**Committee of Experts on the Transport of Dangerous Goods
and on the Globally Harmonized System of Classification
and Labelling of Chemicals****Sub-Committee of Experts on the Transport of Dangerous Goods****Thirty-eighth session**

**Miscellaneous proposals of amendments to the Model Regulations
on the Transport of Dangerous Goods****Comments on ST/SG/AC.10/C.3/2010/39 - Possible use of
flexible bulk containers (FBCs) for the transport of
dangerous goods****Transmitted by the Chairman of the correspondence working group¹****Introduction**

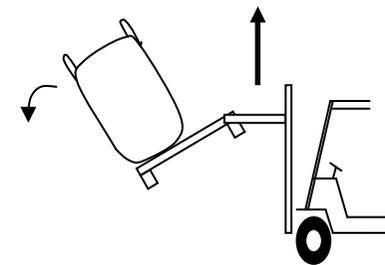
Testing Provisions	Belgium, Sweden, United Kingdom, Germany	<p><u>General Concerns:</u></p> <p>The UK is concerned about the overall stability of the proposed FBCs and does not believe that test procedures based on flexible IBCs properly addresses the dynamic issues encountered during transport for flexible containment systems of this size. In addition the UK does not believe FBCs are suitable for stacking particularly in land transport. The UK does not believe enough evidence has been submitted to demonstrate the FBCs are capable of successfully passing the test procedures when those procedures are rigorously applied.</p> <p><u>Drop test:</u> Belgium is concerned conducting the drop test on bare earth is not equivalent to conducting the drop test on a “rigid, non-resilient, smooth, flat and horizontal surface” (see for example 6.8.5.3.5.3).</p> <p><u>Top lift test:</u> Belgium is concerned the top lift test was not mentioned in UN/SCETDG/35/INF.27/Add.1.</p> <p>Sweden questions whether it is necessary to include a provision for alternative top lift test methods to be used subject to the approval of the competent authority.</p> <p><u>Righting test:</u> Belgium is concerned that the righting test should be conducted in conformance with ISO 16467:2003.</p> <p><u>Topple test:</u> Belgium is concerned the topple test conducted was not in conformance with written theory. See the following illustrations:</p>
